ADDENDUM No. 2

ALAMEDA COUNTY BID #902109

**LAKESIDE BUILDING SECURITY IMPROVEMENTS**

## Lobby Construction phase proposal

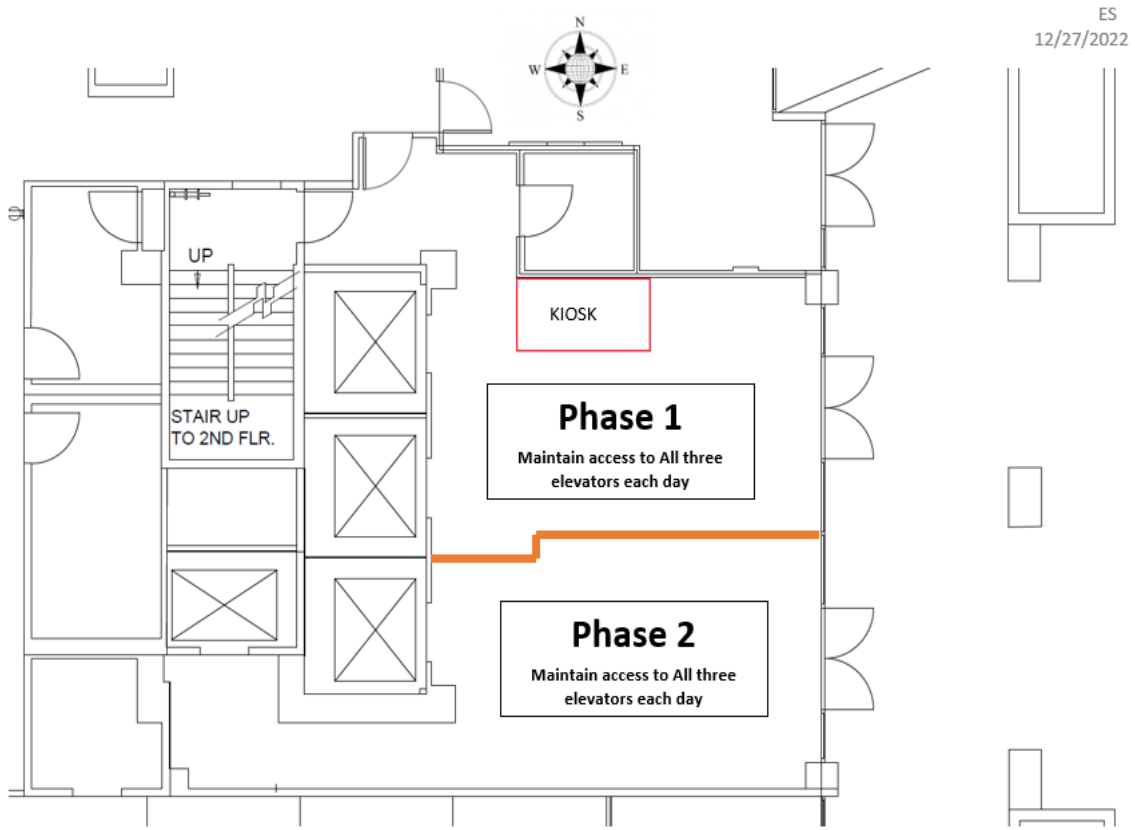
Phase 3- Lobby.

Public access to the building must be maintained during all working hours

North Side

South side

Replace South Entry doors
